UNITED STATES PATENT AND TRADEMARK OFFICE

APPLICATION NO.	FILING DATE	FIRST NAMED INVENTOR	ATTORNEY DOCKET NO.	CONFIRMATION NO.
10/629,873	07/30/2003	Shingo Johgan	4034-39	7357
23117	7590	11/15/2005	EXAMINER	
NIXON & VANDERHYE, PC 901 NORTH GLEBE ROAD, 11TH FLOOR ARLINGTON, VA 22203			WANG, GEORGE Y	
			ART UNIT	PAPER NUMBER
			2871

Office Action Summary	Application No.	Applicant(s)	
	10/629,873	JOHGAN ET AL.	
	Examiner	Art Unit	
	George Y. Wang	2871

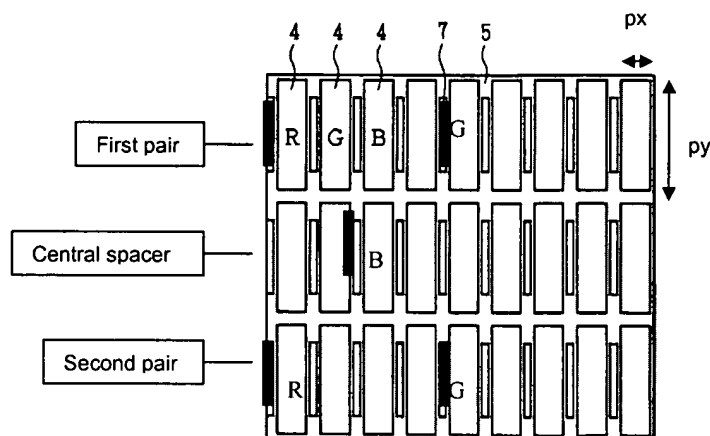
5. As per claims 5-6, Izumi discloses the color filter substrate as recited above, where the color filters are arranged at a predetermined pitch, p_x , in a row direction and at another predetermined pitch, p_y , in a column direction, respectively, and where the spacers include a set of five spacers, the first pair being separated from each other by a distance of $m * p_x$ (where m is an integer equal to or greater than 2 by is not a multiple of 3) in a row direction, the second pair being separated from the spacers of the first pair by a distance of $n * p_y$ (where n is a positive integer and a multiple of 2) in the column direction, and the central spacer being separated from the spacers of the first pair by a distance of $m * p_x/2$ in the row direction and by a distance of $n * p_y/2$ in the column direction, respectively (see clarifying references included by Examiner in fig. 5 below), such that the first pair of spacers and the central spacer consist of a first spacer, a second spacer, and a third spacer associated with the first, second, and third groups of color, respectively, the second pair of spacers and the central spacer consist of

another first spacer, another second spacer, and another third spacer associated with the first, second and third groups of color filters, respectively (see clarifying references included by Examiner in fig. 5 below).
